REFERENCE:	TSB: 23-096-23 GROUP: 23 - Body	Date:	September 12, 2023	REVISION:	-
VEHICLES AFFECTED:	2023 (WS) Grand Wagoneer/Wagoneer This bulletin applies to vehicles built on and after June 06, 2023 (MDH 0606XX) and on and before June 16, 2023 (MDH 0616XX).			MARKET APPLICABILITY: <input checked="" type="checkbox"/> NA <input type="checkbox"/> CH <input type="checkbox"/> EE <input type="checkbox"/> IAP <input type="checkbox"/> SA <input type="checkbox"/> MEA	
CUSTOMER SYMPTOM:	Customers may experience one or more of the following: <ul style="list-style-type: none"> • Right side quarter glass tint is mismatched. • Right side of the vehicle allows more road noise into the vehicle. 				
CAUSE:	Incorrect right side quarter glass installed.

This bulletin involves inspecting and possibly replacing the right side quarter glass.

Fig. 1
Incorrect Right Side Quarter Glass

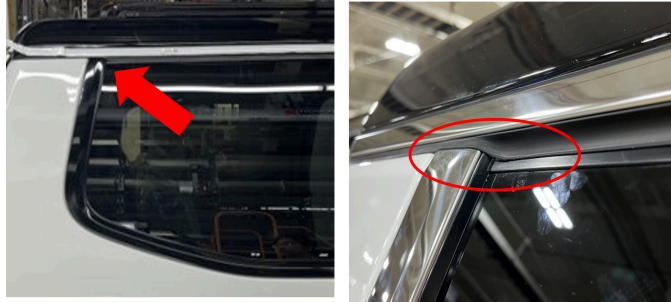
1. Inspect right side quarter glass for a "step", at the top of the glass to its molding (just below the window seal at the D-pillar) [Fig. 1](#) and [Fig. 2](#).

2. Is there a "step" at the top of the glass to its molding (just below the window seal at the D-pillar) [Fig. 1](#) and [Fig. 2](#)?

- YES>>> Proceed to [Step 1](#) of the Repair Procedure.
- NO>>> This bulletin has been completed. Use Inspect LOP (23-30-30-94) to close the active RSU.

1. Replace the right side quarter glass. Refer to the detailed service procedures available in DealerCONNECT> Service Library under: Service Info>23 - Body / Stationary Glass / Glass / Removal and Installation.
